August 5, 2019

**Re: DEP HDD Re-Evaluation Report – Request for Additional Information
Lewisberry Road Crossing 16" Horizontal Directional Drill (S2-0260-16)
Permit No. E67-920
Fairview Township, York County**

Mr. Scott Williamson
Response to DEP Comments on S2-0260-16
August 5, 2019
Page 12

PROFILE VIEW

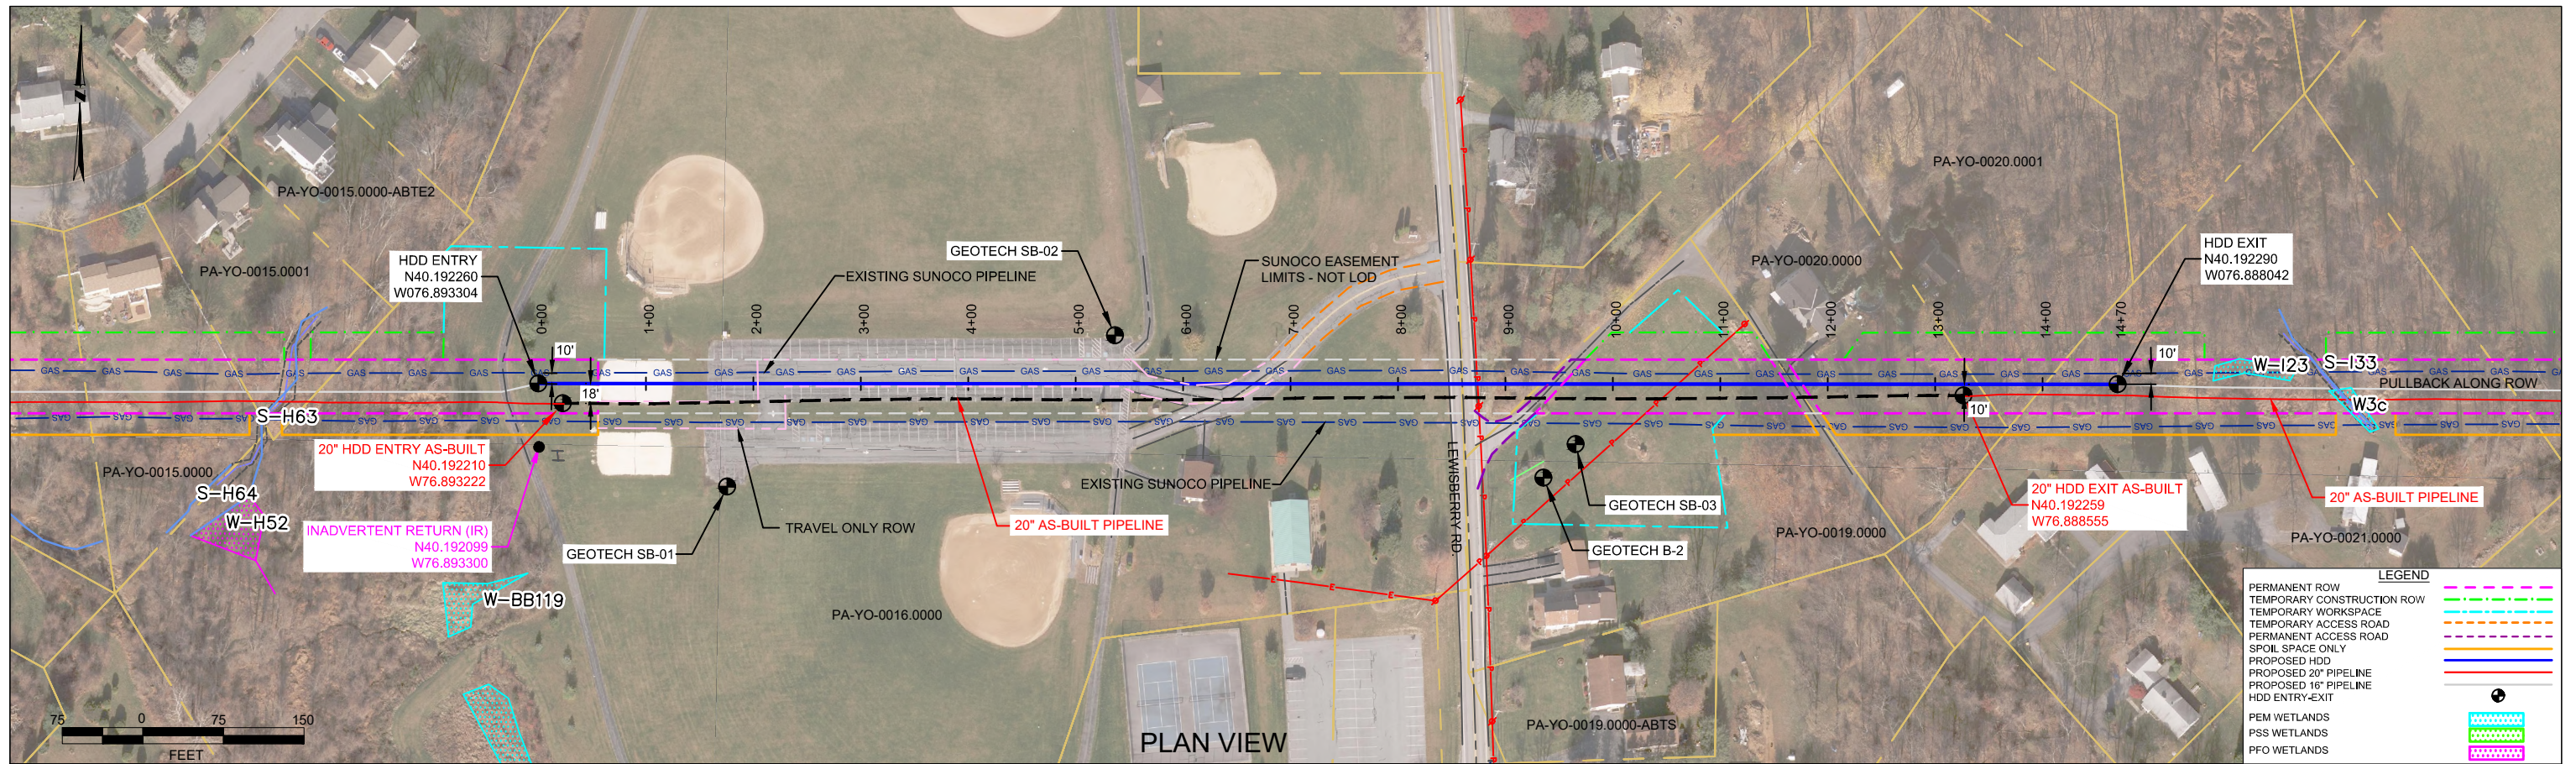
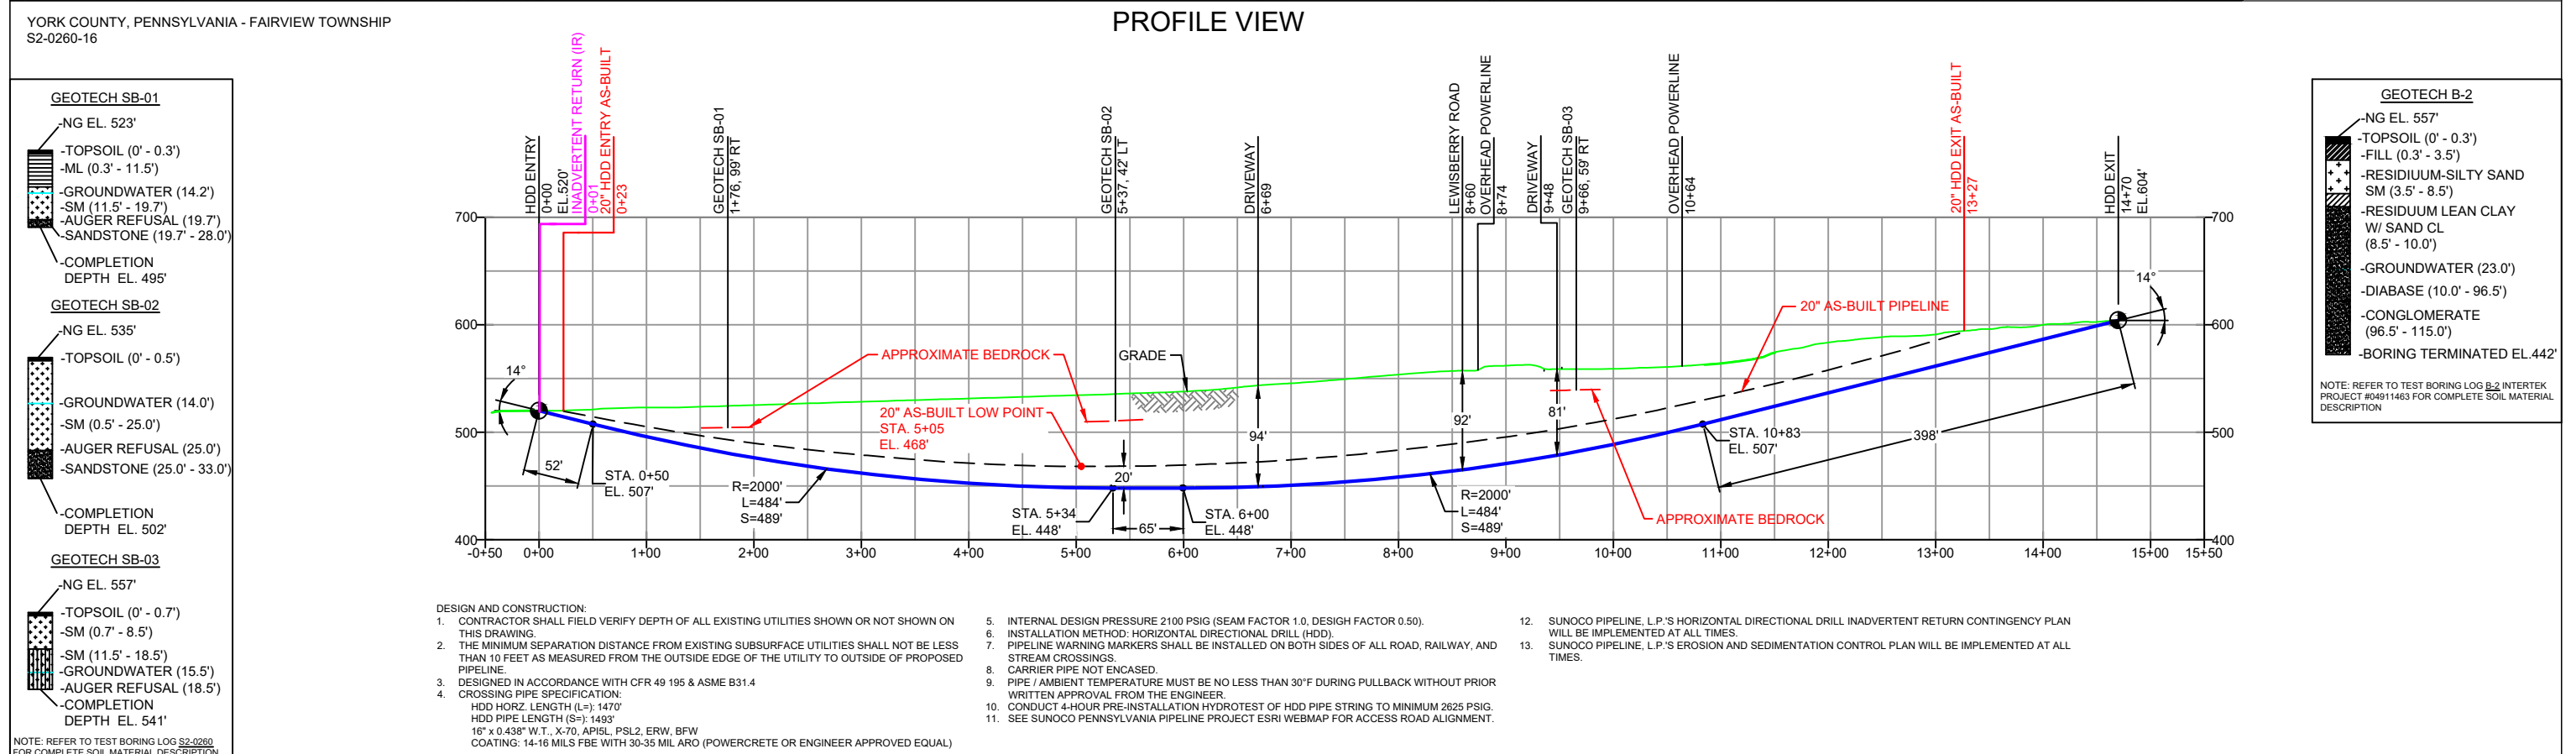
- diii. The description of SB-01 does not match the attached log. The description states the total depth of SB-01 was 7.2 ft. BGS, yet groundwater was encountered at 142 ft BGS. The graphical depiction of SB-01 on the left margins of both the permitted and redesigned 16-inch HDD plan/profile maps is not consistent with the log for SB-01, as it leaves out the cored section from 20-28 ft BGS that was collected after auger refusal at 19.7 ft BGS. Please revise.**

The description of boring SB-01 has been revised to accurately reflect the data gathered during the 2014 geotechnical investigation. The total depth of the boring was 28 feet bgs, with auger refusal occurring at a depth of 20 feet bgs. The cores consisted of unconsolidated silts with fine sands to a depth of 8 feet bgs and sand with silts and weathered sandstone from 8 to 20 feet bgs. The rock cores collected between 20 and 28 feet consisted of weathered sandstone bedrock. The graphical representation of boring SB-01 on the permitted and redesigned 16-inch HDD profile have been revised to include the bedrock core descriptions.

REF. DRAWING		REVISIONS	
ES-04	TO	NO.	DESCRIPTION
ES-04	TO SHEET 3	EP4	REVISED GEOTECH SB-01 INFORMATION
SHEET 3	TO SHEET 3	EP3	DESIGN CHANGE - INCREASED DEPTH AND LENGTH OF DRILL, ADDED GEOTECH DATA
		EP2	REVISED PER PADEP COMMENTS RECEIVED 09-06-16
		EP1	REVISED PER PADEP COMMENTS
		EP	
		B	ADDED GEOTECH INFO

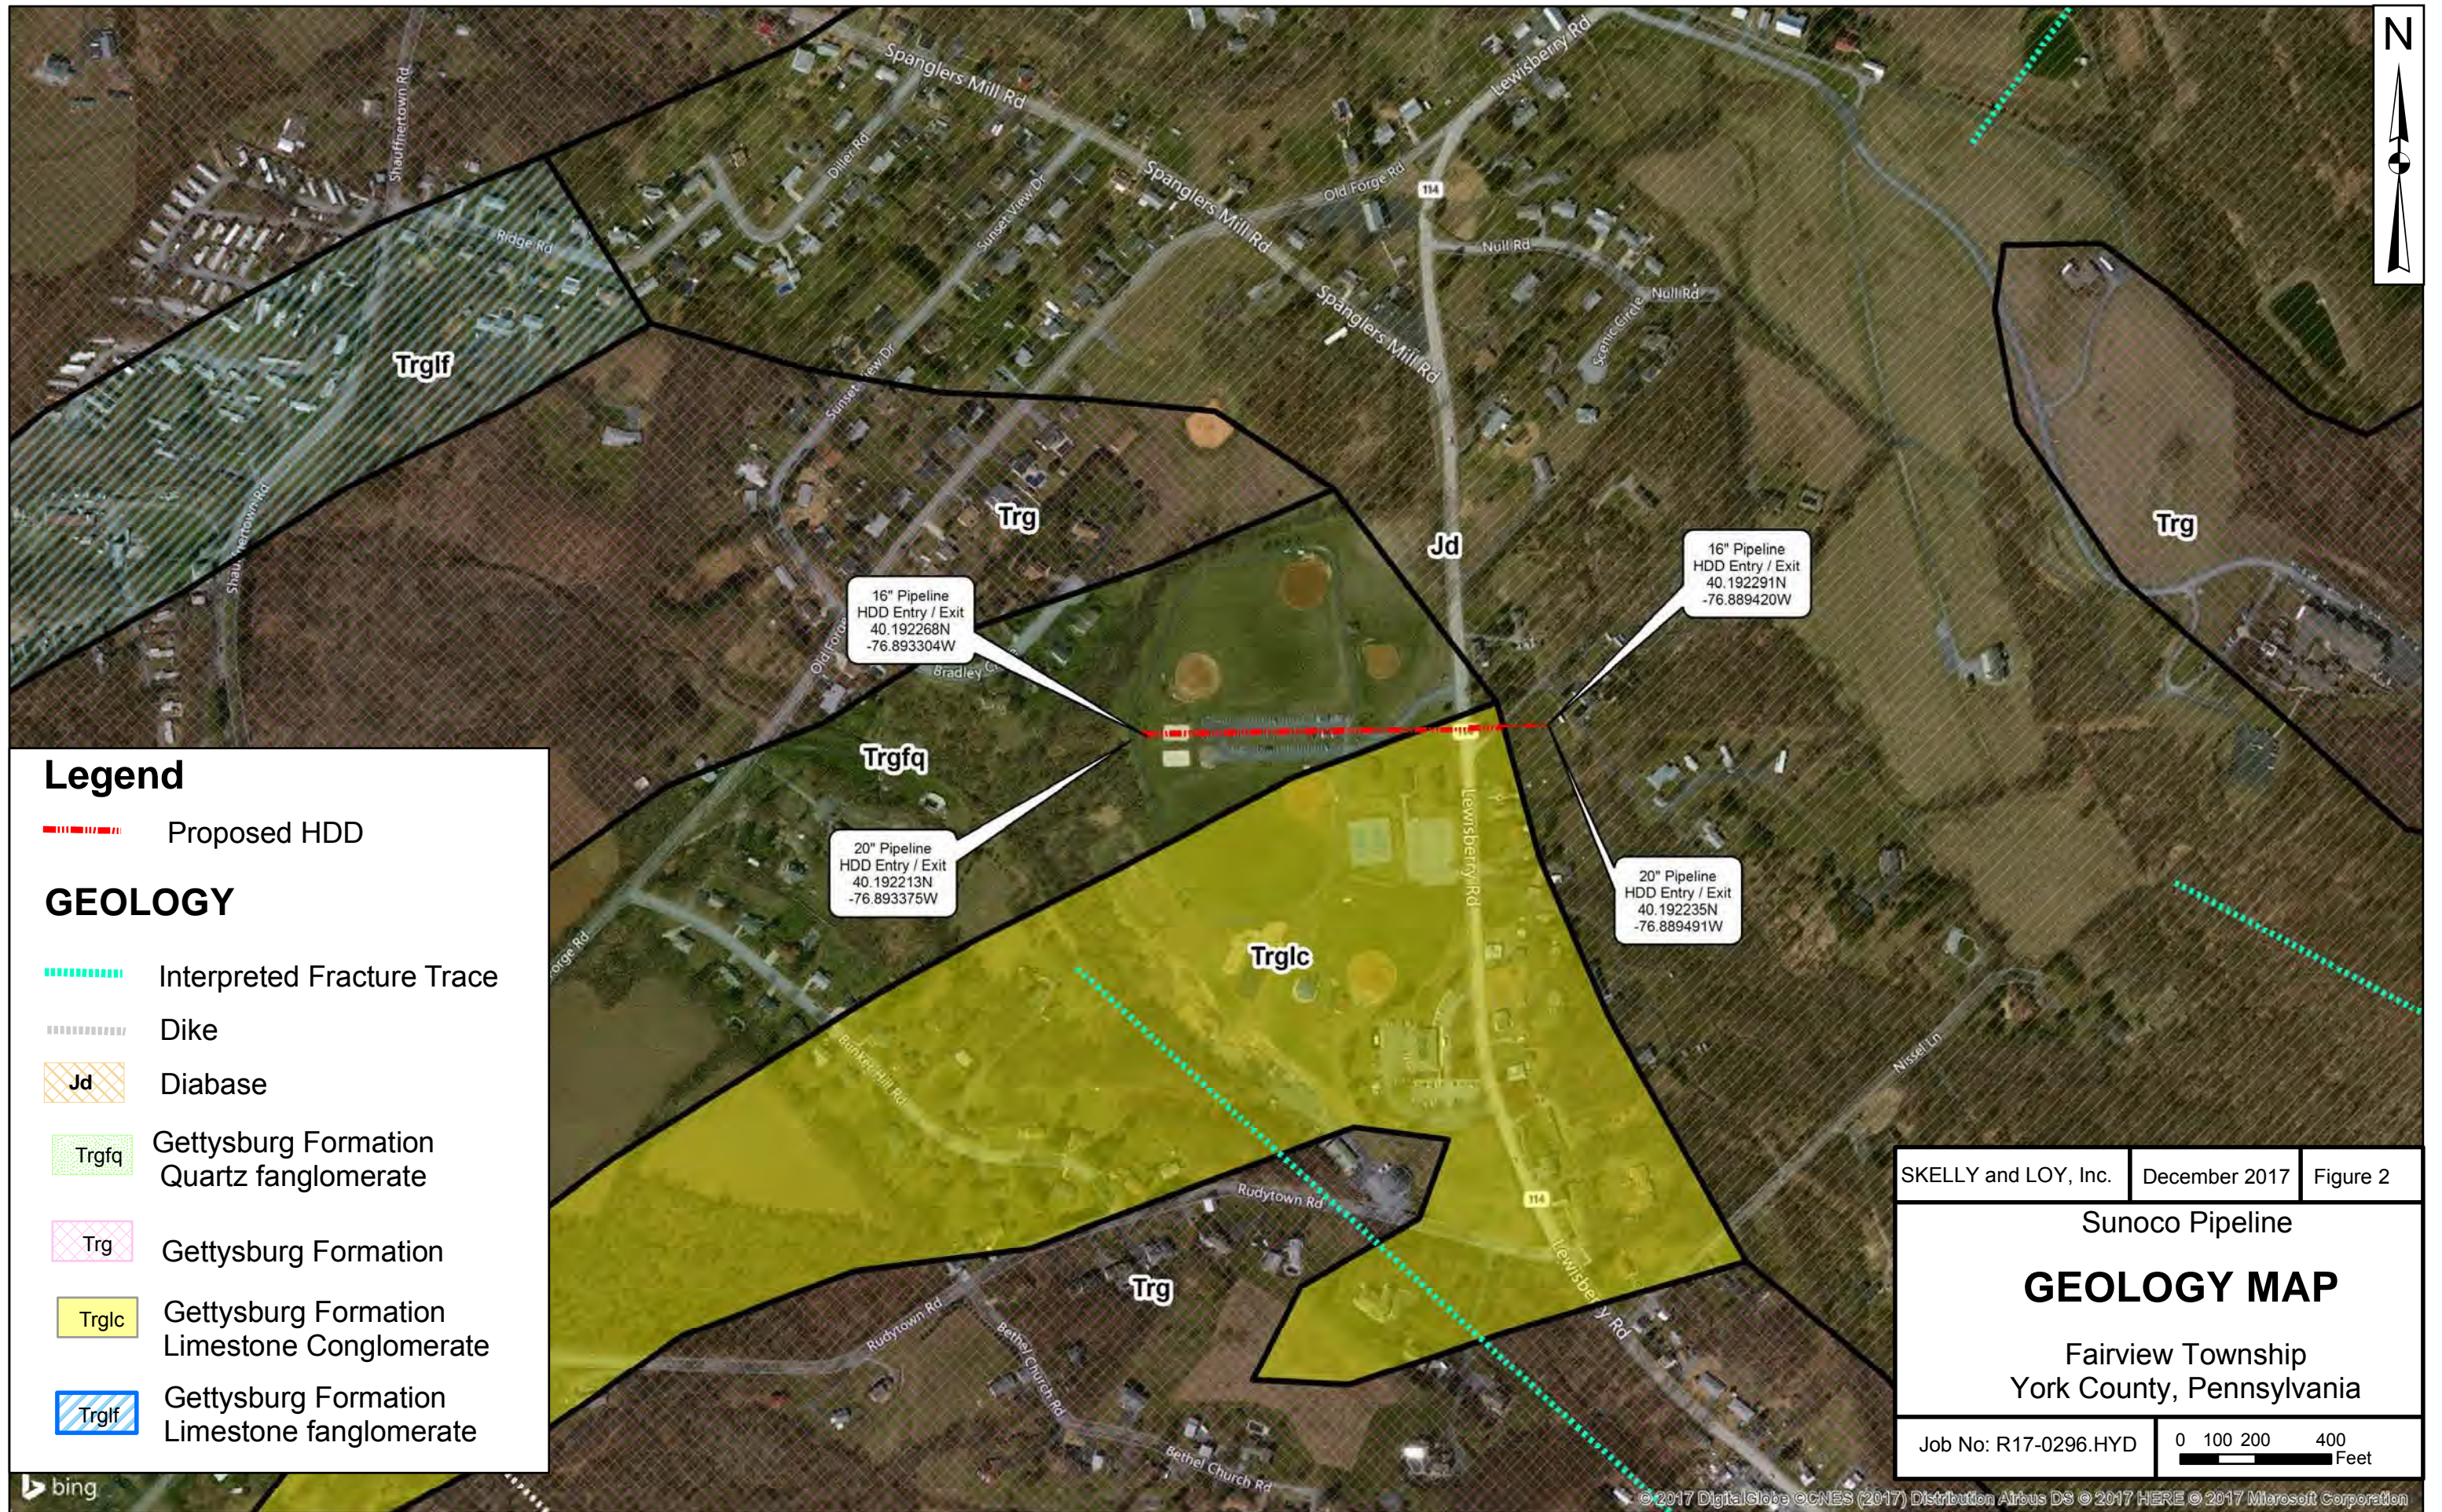
ei. **States "the only limestone conglomerate mapped in the area of the site is located approximately 2,000 feet NW of the HDD bore path." Skelly and Loy's Figure 2 Geology Map shows Gettysburg Formation Limestone Conglomerate underlying the east-central portion of the path, between the Gettysburg Formation Quartz Fanglomerate to the west and diabase to the east. Please clarify or revise.**

The Report has been revised to include the Gettysburg Limestone Conglomerate along the east-central portion of the HDD profile. The revised report is attached.
